ARCHITECT'S SUPPLEMENTAL INSTRUCTIONS

PROJECT:	Lee Lofts II – Tenant Space 2 Offices Salina, Kansas	Report No.	One (1)
OWNER:	Overland Property Group Dan Maximuk 234 N. Santa Fe Ave, Suite A Salina, KS 67401	Date	Oct. 14, 2024
CONTRACTOR:	MCP Group 3501 SW Fairlawn Rd. Topeka, KS 66614	Architect's Proj No.	24-3420
		Contract For:	General Construction Mechanical, Electrical

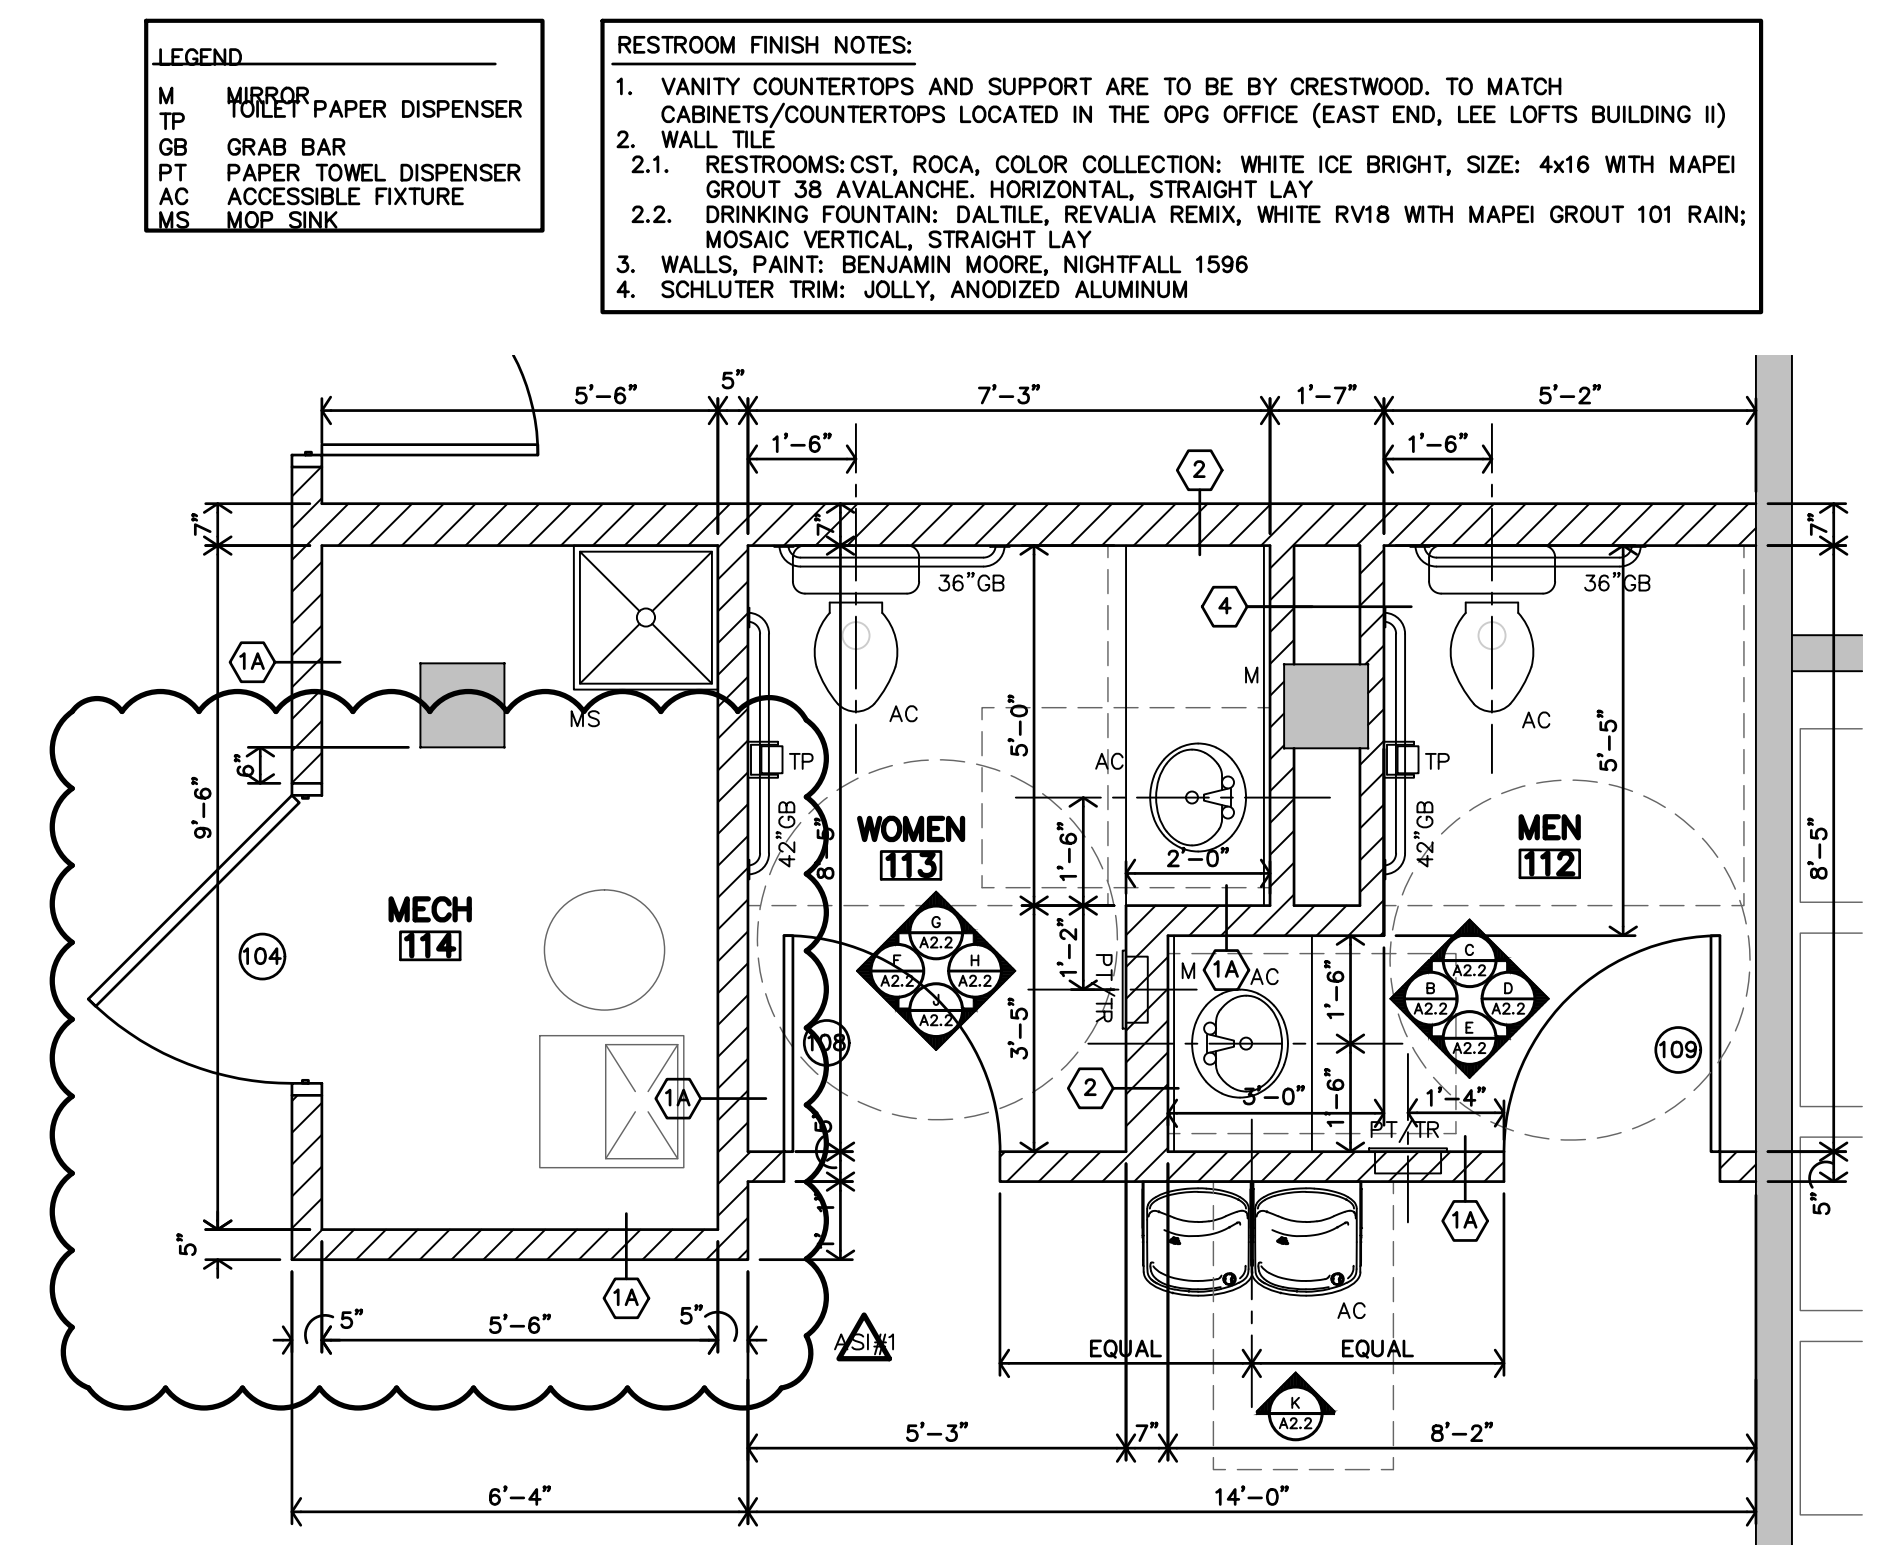
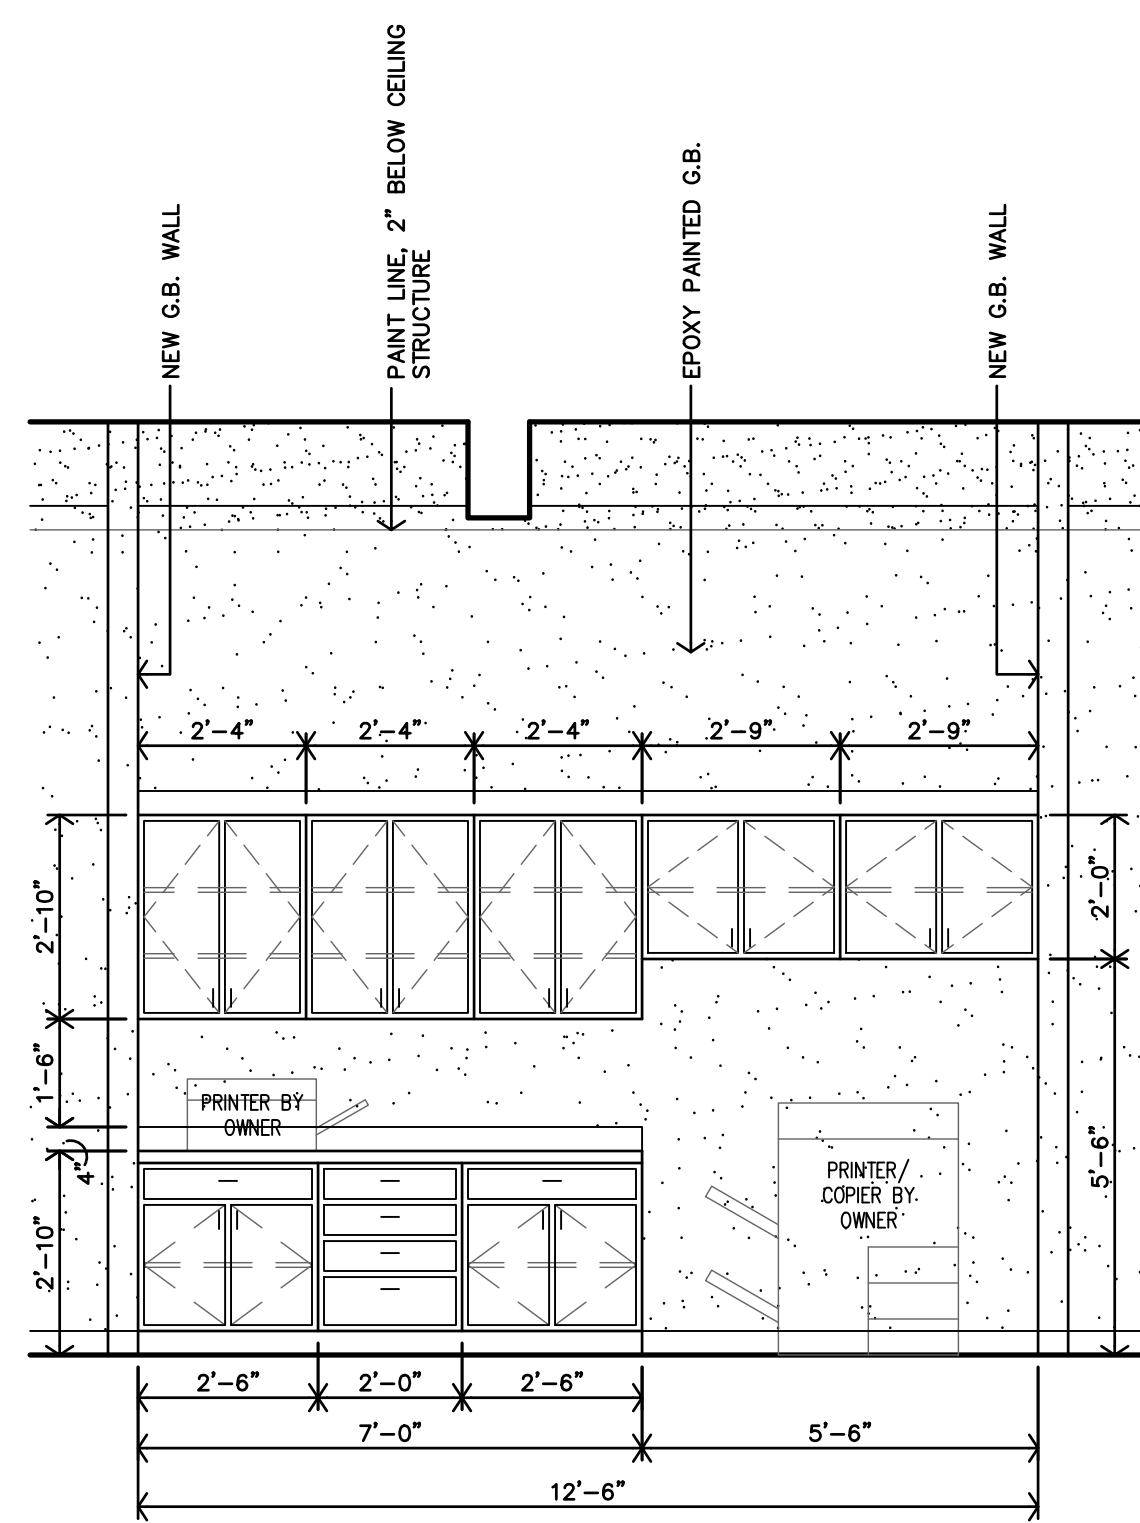
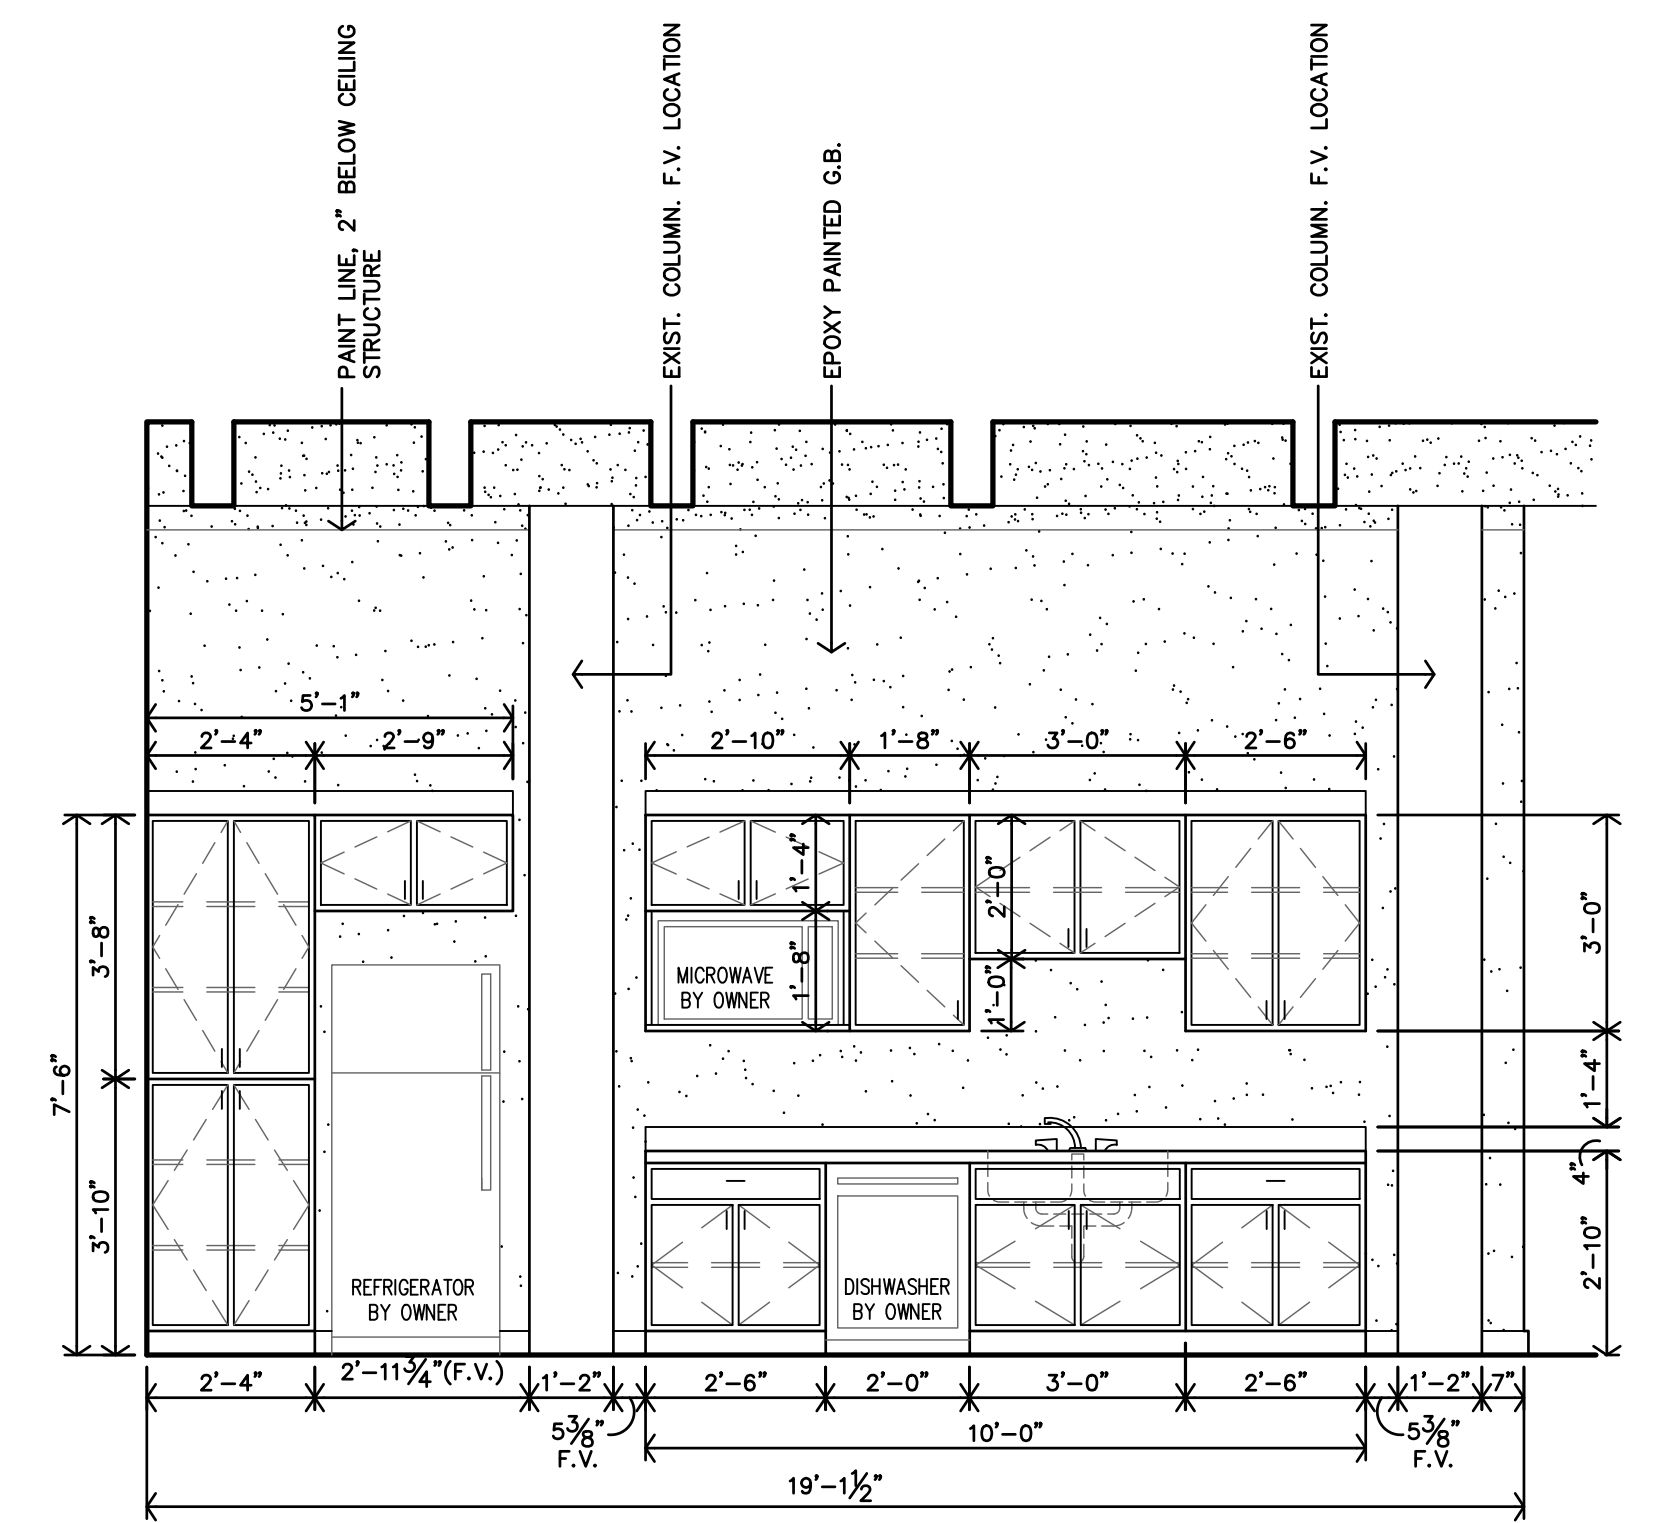
- b. Sheet A2.2 – revised to show modification to mechanical room size and door size and configuration.
 - c. Sheet A2.3 – revised to show modification to door #104 size and configuration.

① **COMMERCIAL SPACE #2 HVAC PLAN**
1/4" = 1'-0"

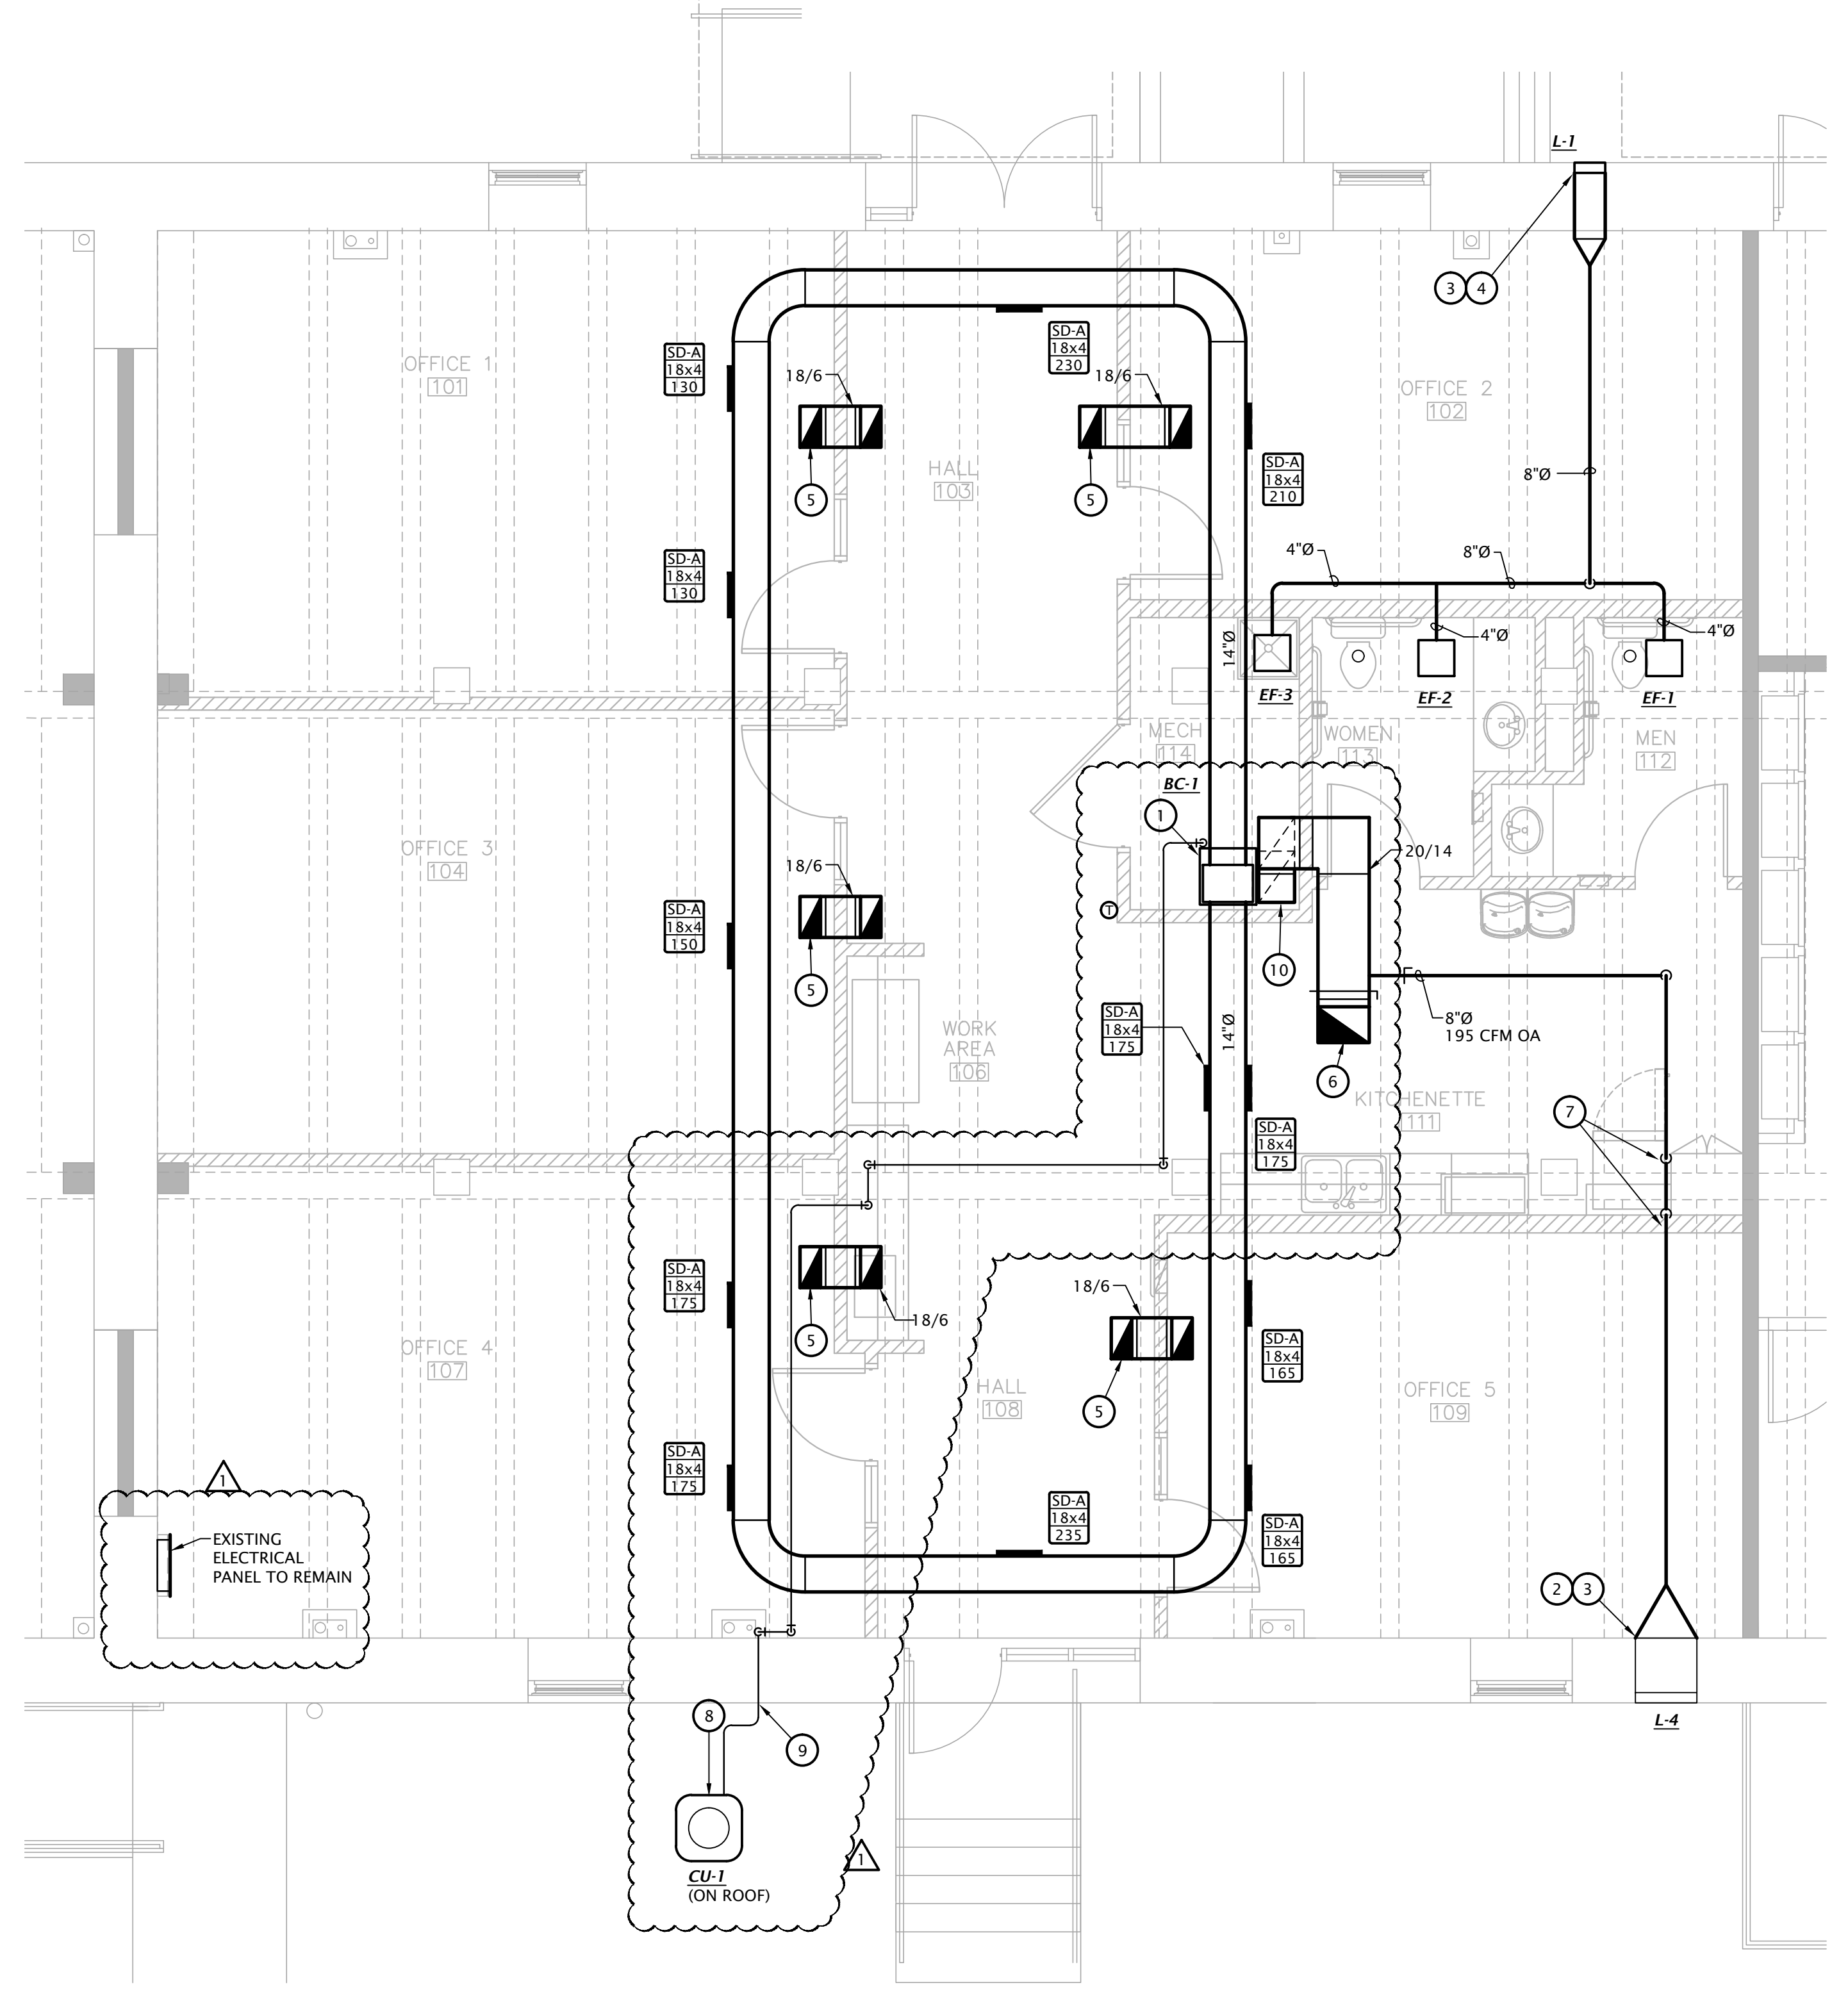
- d. Sheet M1.1 – revised to show condensing unit to grade, blower coil unit location and ductwork was revised for modification to mechanical closet size, and electrical panel is to remain in existing location.

8. MOUNT CONDENSING UNIT ON 3-1/2" THICK LEVEL CONCRETE PAD ON GRADE. COORDINATE WITH G.C. AND ARCH.
9. ROUTE REFRIGERANT PIPING FROM CONDENSING UNIT ON ROOF TO BLOWER COIL. PENETRATE EXTERIOR WALL 18" A.F.G. MIN. AND UTILIZE AIREX TITAN WALL PENETRATION SEAL AT PENETRATION OF EXTERIOR WALL. ROUTE PIPING CONCEALED IN WALLS/ CHASE ON INTERIOR OF EXISTING WALL. ROUTE PIPING THROUGH EXPOSED CEILING SPACES AS HIGH AS POSSIBLE AND IN BETWEEN EXISTING JOISTS WHERE POSSIBLE. COORDINATE EXACT ROUTING WITH ARCHITECT PRIOR TO INSTALLATION.
